Sent: 18/10/2023 3:39:28 PM
Subject: TRIMMED: DA 2023 1289 1112-1116 BARRENJOEY ROAD PALM BEACH
WRITTEN SUBMISSION: LETTER OF OBJECTION SUBMISSION: TULLOCH
Attachments: 1116 BR WS.pdf;

RE: DA 2023 1289
1112-1116 BARRENJOEY ROAD PALM BEACH
WRITTEN SUBMISSION: LETTER OF OBJECTION
SUBMISSION: TULLOCH

This document is a written submission by way of objection lodged under Section 4.15 of the EPAA 1979 [the EPA Act].

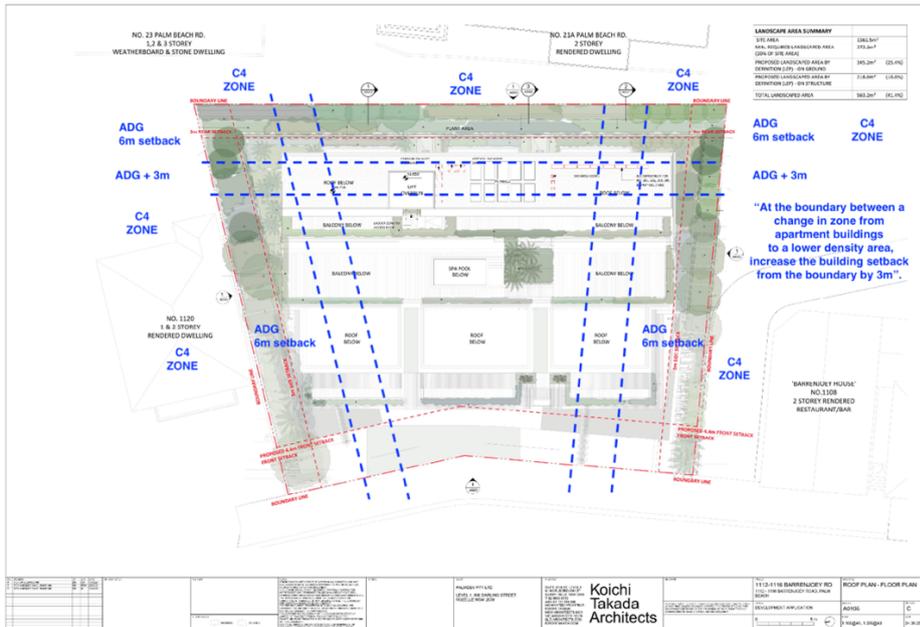
I contend that the design should better reflect Barrenjoey House, in terms of wall height and ridge height, with a design that better responds to the solid to void relationship of Barrenjoey House.

E. REQUEST FOR AMENDED PLANS TO BE SUBMITTED TO BETTER ADDRESS IMPACTS UPON ADJOINING PROPERTIES

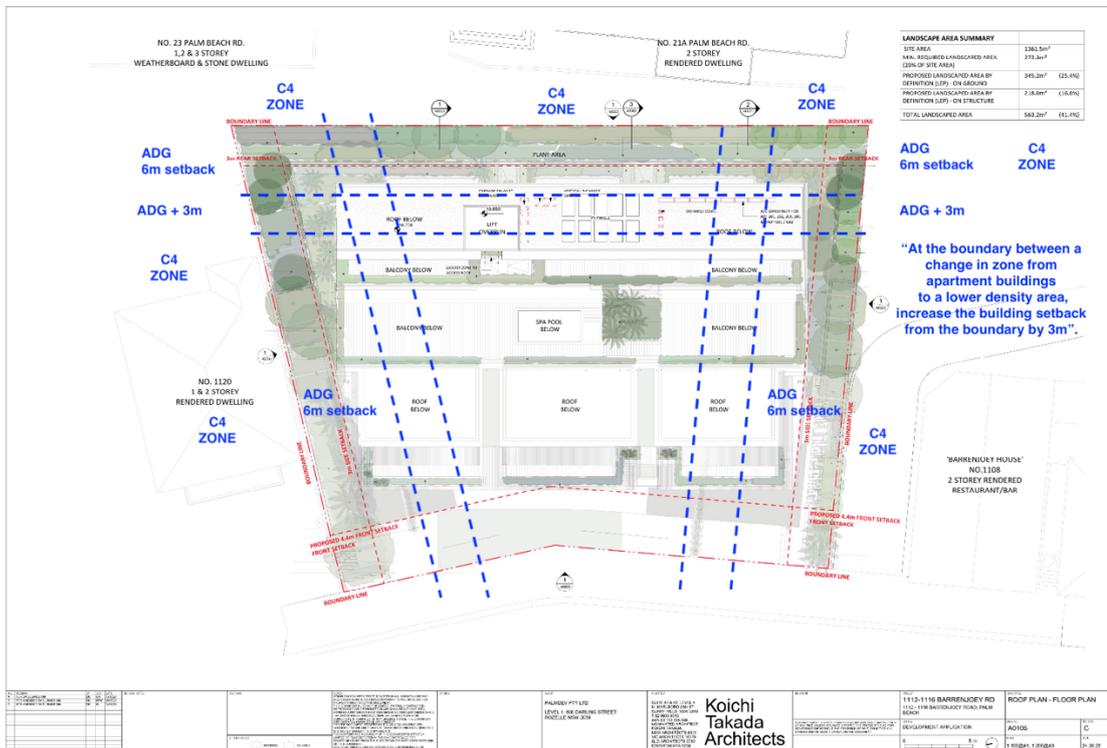
A compliant building design would reduce the amenity impacts identified.

Prepare and submit further supporting information and amendments to the assessing officer directly addressing the issues.

A compliant design to LEP & ADG controls

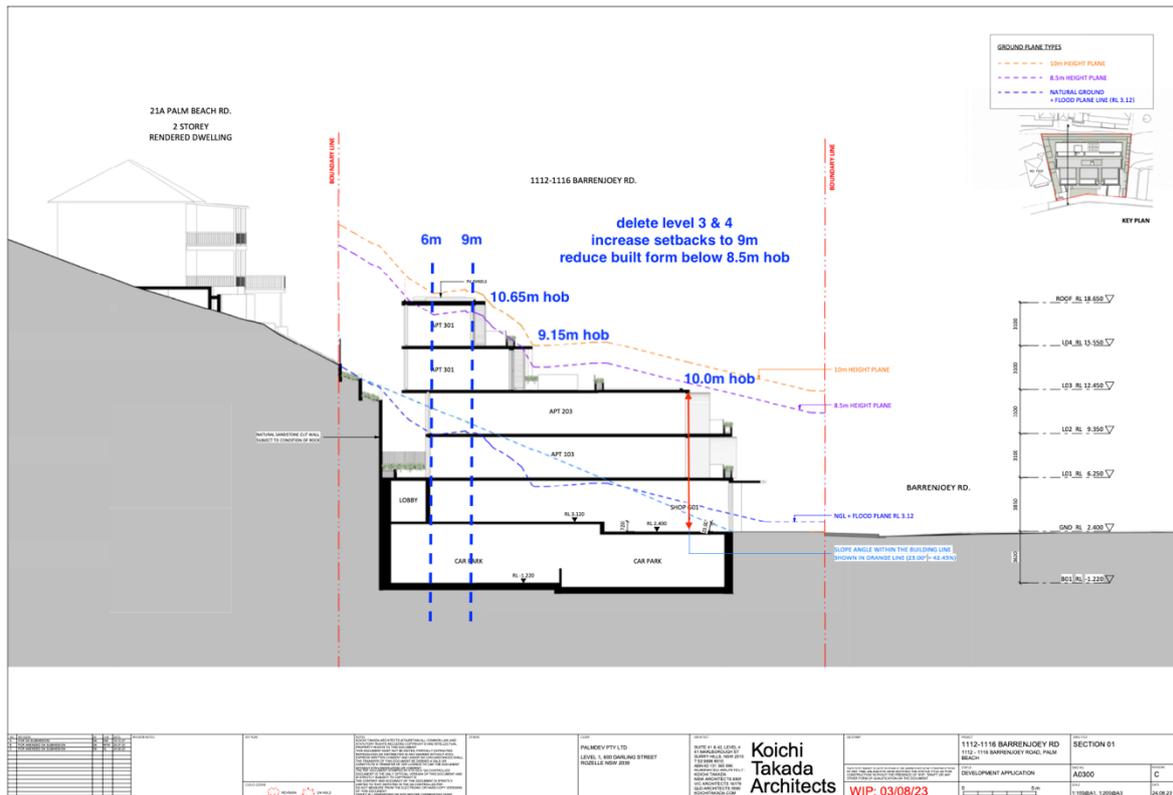
- Reduce the Building Height to 8.5m
- Increase Side & Rear Setback to ADG controls, of 6m + 3m = 9m, due to change of zone from E1 to C4
- Delete Levels 3 & 4.
- Consider to a two-storey pavilion facing the street to match wall and ridge heights of Barrenjoey House, with solid to void fenestration to match the heritage item, with bedrooms in the roof space.
